SUNDRY NOTICES AND REPORTS ON WELLS
Do not use this form for proposals to drill or to re-enter an abandoned well. Use form 3160-3 (APD) for such proposals.

1. Type of Well <input checked="" type="checkbox"/> Oil Well <input type="checkbox"/> Gas Well <input type="checkbox"/> Other		8. Well Name and No. THUNDERBIRD A 5H ✓	
2. Name of Operator APACHE CORPORATION /		Contact: SORINA FLORES E-Mail: sorina.flores@apachecorp.com	9. API Well No. ✓ 30-015-44436-00-X1
3a. Address 303 VETERANS AIRPARK LANE SUITE 3000 MIDLAND, TX 79705		3b. Phone No. (include area code) Ph: 432.818.1167	10. Field and Pool or Exploratory Area LOCO HILLS-GLORIETA-YESO
4. Location of Well (Footage, Sec., T., R., M., or Survey Description) Sec 33 T16S R30E SWNE 2315FNL 1955FEL ✓ 32.878929 N Lat, 103.974731 W Lon		11. County or Parish, State EDDY COUNTY, NM ✓

APACHE RESPECTFULLY REQUEST A VARIANCE TO USE A FLEXIBLE HOSE BETWEEN BOP & CHOKE MANIFOLD. SEE ATTACHMENT FOR ADDITIONAL INFORMATION.

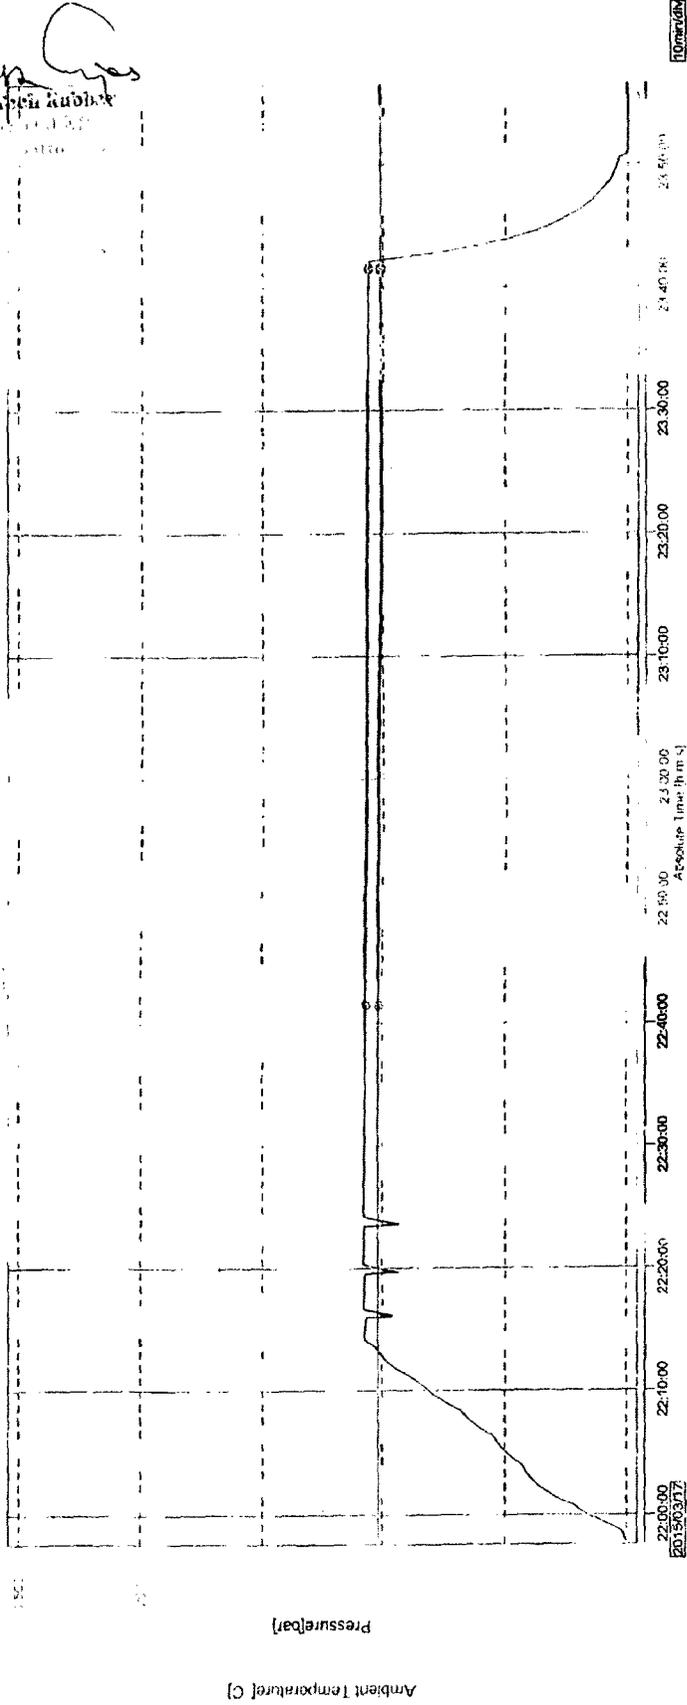
Manufacturer: continental
Length: 35'
Inside Diameter: 3"
WP Rating: 10,000psi
TP Rating: 15,000psi

1. Variance approved to use flex line from BOP to choke manifold. Check condition of flexible line from BOP to choke manifold, replace if exterior is damaged or if line fails test. Line to be as straight as possible with no hard bends and is to be anchored according to Manufacturer's requirements. The flexible hose can be exchanged with a hose of equal size and equal or greater pressure rating. **Anchor requirements, specification sheet and hydrostatic pressure test certification matching the hose in service, to be onsite for review. These documents shall be posted in the company man's trailer and on the rig floor.** If the BLM inspector questions the straightness of the hose, a BLM engineer will be contacted and will review in the field or via picture supplied by inspector to determine if changes are required (operator shall expect delays if this occurs).
